STAFF REPORT

Department of Metropolitan Development
Division of Planning
Current Planning Section

Case Number: 2023-CVR-832 / 2023-CPL-832 (Amended)
Address: 2144 East 12th Street (Approximate Address)
Location: Center Township, Council District #17
Zoning: D-5
Petitioner: Bybee Holdings LLC, by Jynell D. Berkshire
Request: Variance of development standards of the Consolidated Zoning and Subdivision Ordinance to provide for the subdivision of a 5,700 square foot lot into two lots, with:

Approval of a Subdivision Plat to be known as Bybee's 12th Street Addition, a replat of Lot 18 in Joseph A. Moore's Addition, subdividing 0.14 acre in to two lots.

SITE PLAN

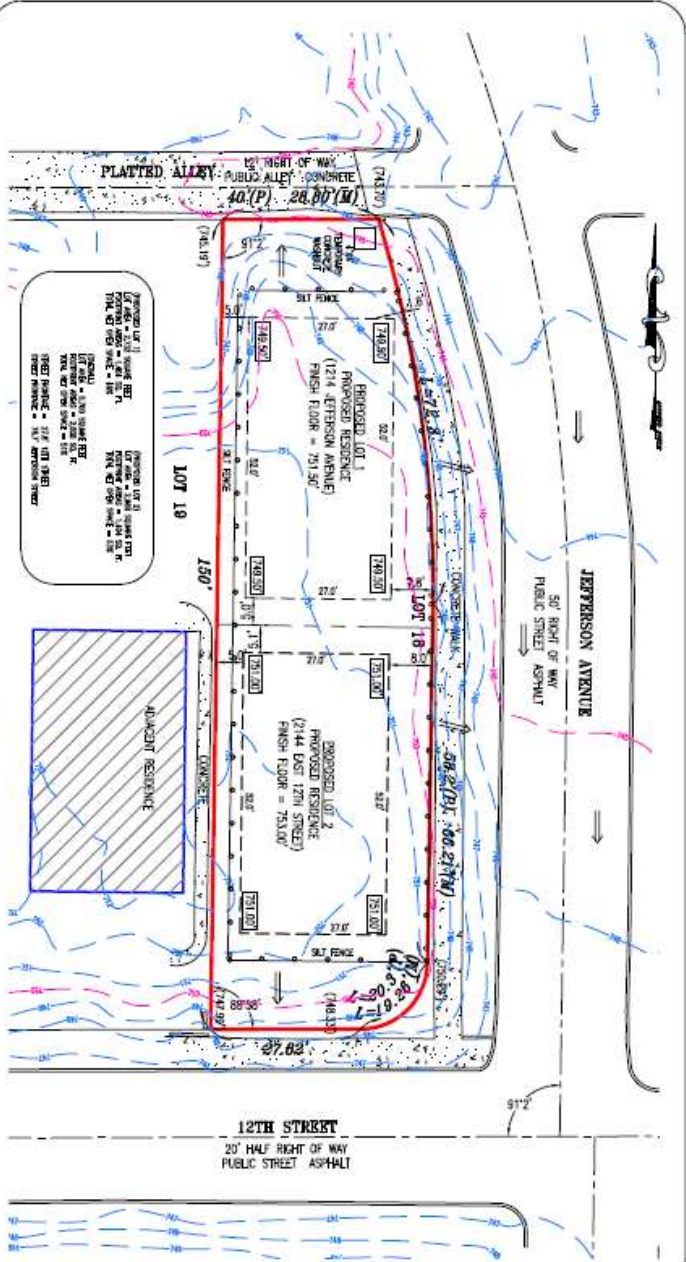
Staff would note there is also an elevation change on the north end of proposed Lot One, as shown on the survey below. Staff has concerns with how placement of a manufactured home will address the existing topography. The developer has provided correspondence that a foundation will most likely be a block foundation that will be partially above grade. Proposed Lot One will front on Jefferson Avenue to the east, and the proposed five-foot north side yard meets standards, but staff believes this layout is not compatible with the existing neighborhood development pattern.

- ◇ This request would provide for construction of a single-family dwelling on Lot One with a front yard setback of 1.8 feet where ten feet is required, and a rear setback of five feet where 20 feet is required.

- ◇ Staff would not recommend approval of the 1.8-foot front setback on Jefferson Avenue. Staff would note that the proposed dwelling floor area could be modified or reduced to meet the required setback, and is therefore not supportive.

- ◇ The proposed Lot One is oriented so that its frontage is on the east, making the lot depth only forty feet. This would make the rear yard align with the side yard of adjacent lots, which have a minimum setback of five feet. Staff would note that most lots' rear yards are on the alley while this orientation puts the alley access in the side yard. Given the general placement of the structure is consistent with the north and east/west setbacks of the neighborhood, staff is not opposed to the five-foot rear setback.

- ◇ This request would provide for construction of a single-family dwelling on Lot Two with a 5.1-foot rear yard setback where 20 feet is required. Staff would note that the compact lot standards allow for a 15-foot setback, which would be more appropriate for a lot of this size. Staff would also note that although the front setback could be decreased so that the rear yard could be increased, the current front setback is more consistent with the neighborhood lot averages. Staff would not be opposed to a reduced rear setback where all other setbacks and open space are met, and where the proposed dwelling placement is consistent with the neighborhood development patterns.
